#PLN-2021-00156
551 Congress Parkway – Conceptual PUD
Project Review for Planning and Zoning Commission

<u>Meeting Date:</u>	September 15, 2021
<u>Request:</u>	Conceptual Planned Unit Development review for a 144-unit apartment development
<u>Location:</u>	551 Congress Pkwy
<u>Acreage:</u>	Approximately 6.62 acres
<u>Zoning:</u>	M Manufacturing
<u>Surrounding Properties:</u>	North: M Manufacturing South: M Manufacturing & B-2 General Commercial East: M – Manufacturing West: B-2 PUD General Commercial & O PUD Office
<u>Staff Contact:</u>	Katie Rivard (815.356.3612)

CONCEPT PLAN 1"=100' N 9/12/21

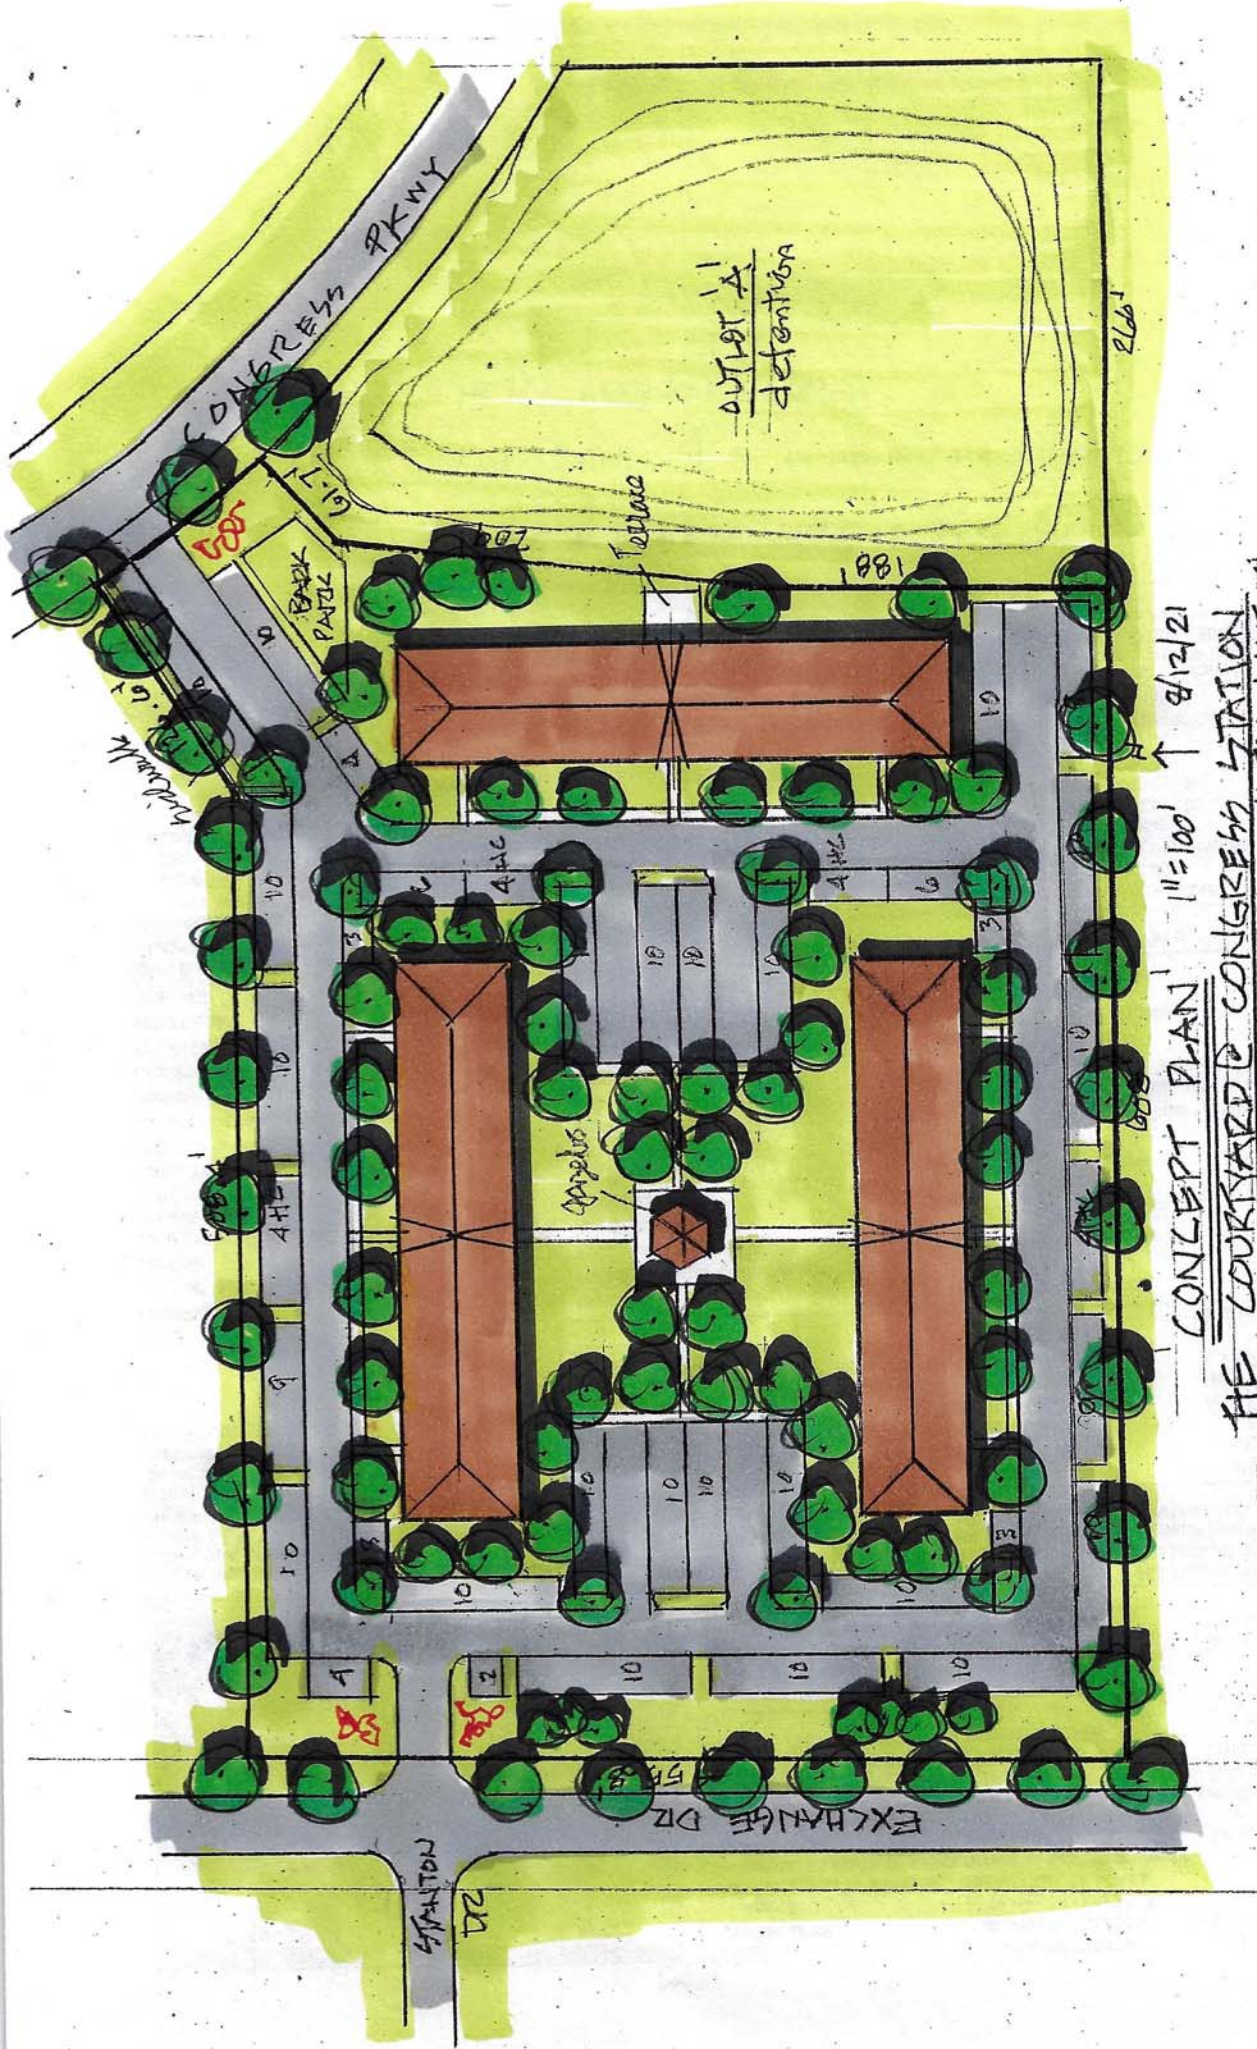
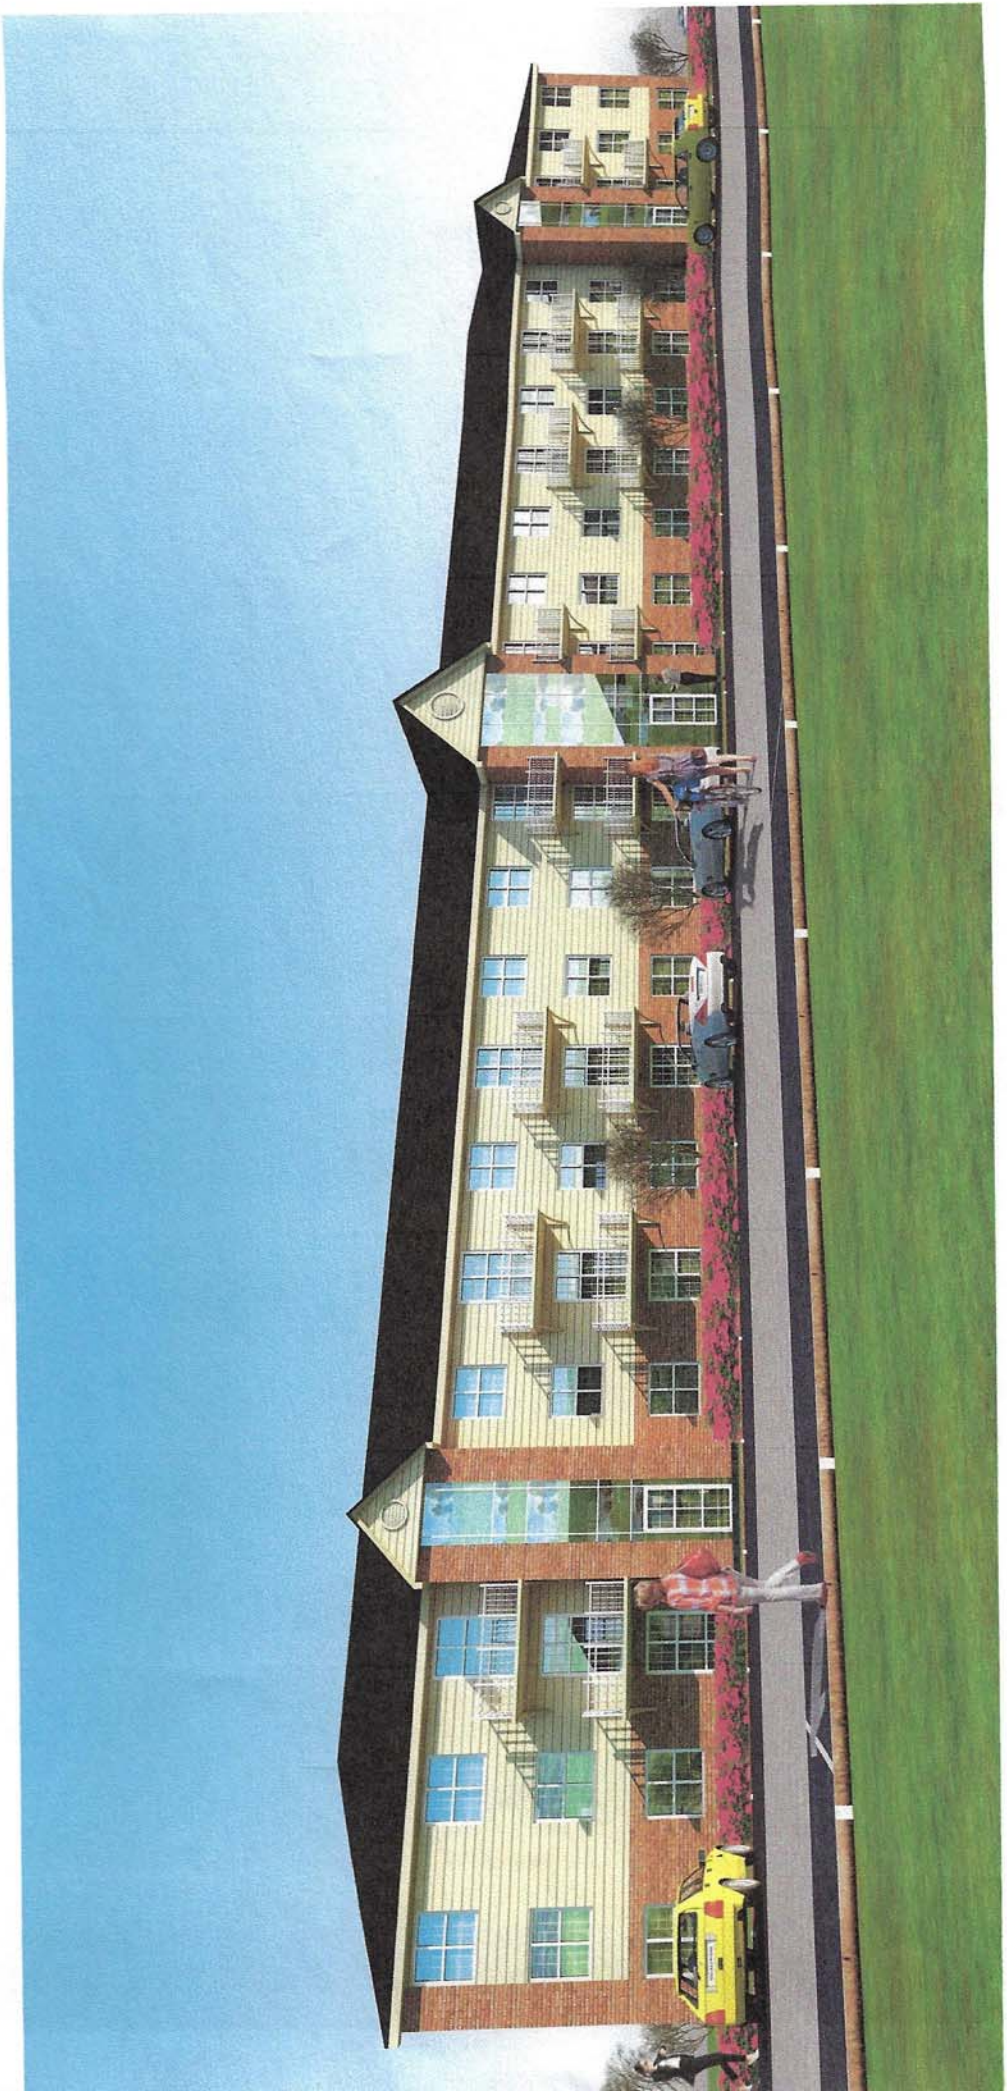
- Based on the submitted plans, the proposed development does not meet the requirements for lot area or lot width. Per the R-3B standards, 13.26 acres are required to meet the lot area requirements, and 1,490 feet is required to meet the lot width requirements.

- Access into the site would be provided off Exchange Drive and Congress Parkway. The access onto Exchange Drive lines up with Station Drive.
- The exit on Exchange Drive could potentially create traffic concerns for vehicles exiting the development as there is minimal area for vehicles to queue.
- The total width of the community drive aisles are 26 feet, which is the minimum necessary to comply with the requirements of the Fire Rescue Department.
- The site layout provides green space throughout the development most predominately between the two center (horizontal) buildings, as well as, on the northeast portion of the development. The amenities include a grassy community area with gazebo and a dog park.

- Sidewalks and parkway trees are required along all roadway frontages. Sidewalk connections are provided between buildings. There is an existing sidewalk along the frontage on Exchange and the sidewalk along the Congress Parkway frontage would need to be added.
- A detention area provides a buffer between the eastern building and Congress Parkway.

- The minimum number of wall offsets for a 288-foot long building is 6. Based on the submitted plans, 3 offsets are proposed. Additional projections could be provided through more detailed column features.

- Surface parking would be utilized for the multi-family apartment buildings.
- Based on the submitted plans, 296 parking spaces would be required for the residential units (1.75 spaces per 1-bedroom unit and 2.25 spaces per 2-bedroom unit) and 297 spaces are provided.
- Per 4-400 F, additional landscaping must be provided on the perimeter of the project for screening of headlights.

- Currently, the stormwater detention is shown off-site. Detailed engineering reports and calculations will need to be provided to ensure this lot can drain into this basin at the proposed impervious surface coverage.
- Per the submitted plans, the impervious coverage is listed at 60%, which is the maximum impervious coverage allowable in the R-3B zoning district. The petitioner will need to submit accurate impervious coverage calculations with future submittals for additional staff review.

SECOND & THIRD FLOOR PLAN 1/32"
CRYSTAL HEIGHTS CONGRESS STATION 7/19/21

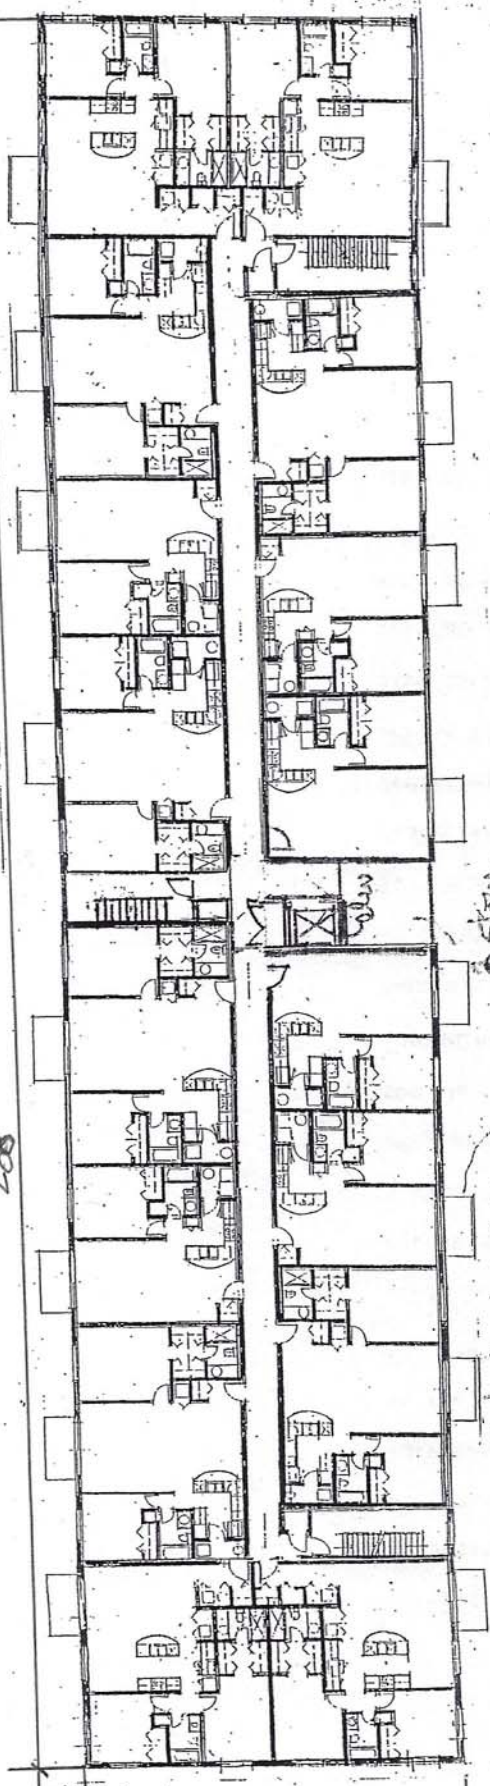
- As proposed, the elevations provide monotonous windows, large roof expanses, and minimal architectural elements. The buildings are required to meet 4-900 D, with one optional standard and all mandatory standards. The standards are outlined below.

- All buildings shall be provided with complex massing configurations with a variety of wall planes and roof planes.
 - Based on the submitted plans, the proposed wall planes include minimal column features to break up the long building expanse, and the roof plane includes a gable style roof only.

- All buildings shall be designed with a variety of different wall planes. Plain, monolithic structures with long, monotonous unbroken wall surfaces are not permitted. Wall offsets are required every 50 feet of frontage. Wall offsets should be meaningful and noticeable at least 2 feet.

- Front facades shall provide at least three of the following design features:
 - One or more dormer windows or cupola - not provided
 - A recessed entry - not provided

- A covered porch - not provided
 - Pillars, posts or pilasters - not provided
 - One or more bay windows with a minimum projection of 12 inches from the façade planes - not provided

- Eaves with a minimum six-inch projection from the façade plane - provided
 - A parapet wall with articulated design - not provided
 - Multiple windows with a minimum four-inch-wide trim - not provided

- The maximum length of a multi-family dwelling shall be 200 feet.
 - The proposed building length is 288 feet.

FIRST FLOOR PLAN 1/32"

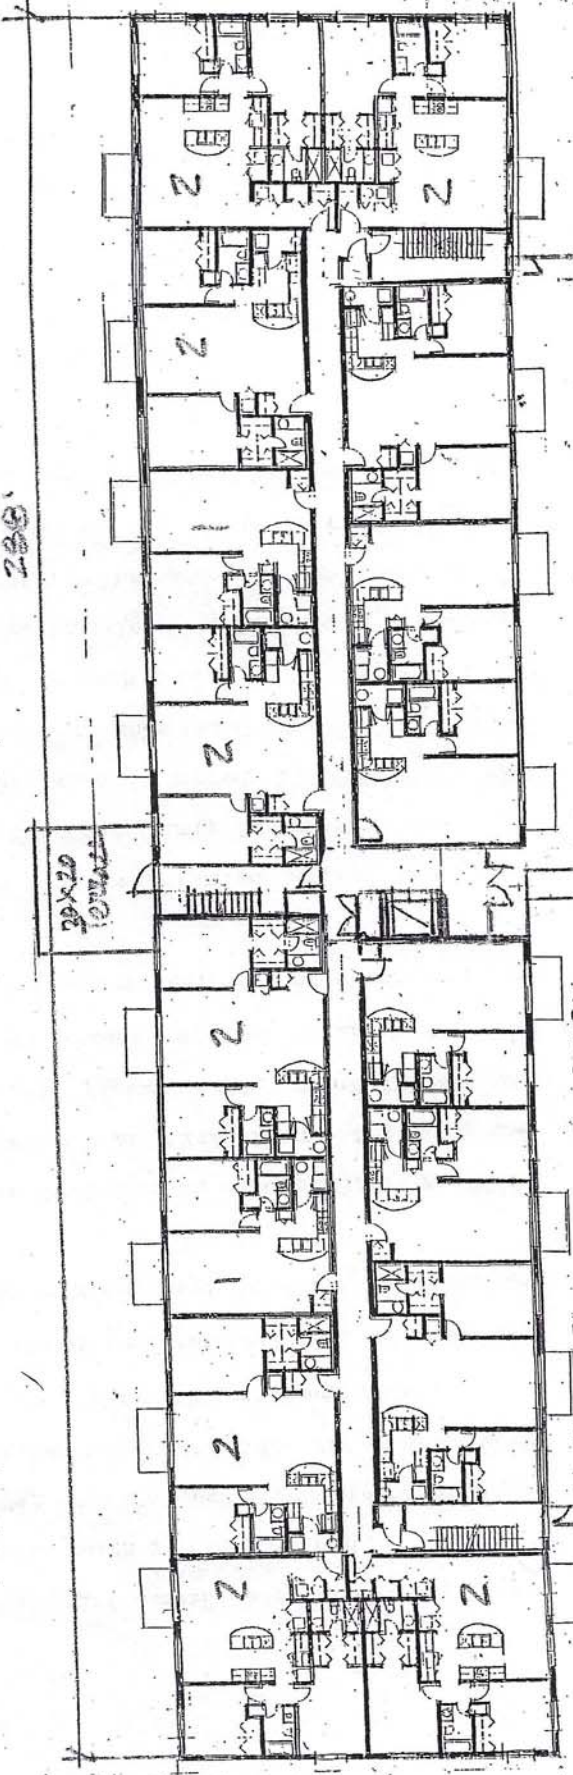
- The buildings are 3-stories with brick on the first level and Hardi-Board siding on the top two levels.
- Each first floor unit will be provided a patio, and each second and third story units will be provided a balcony.
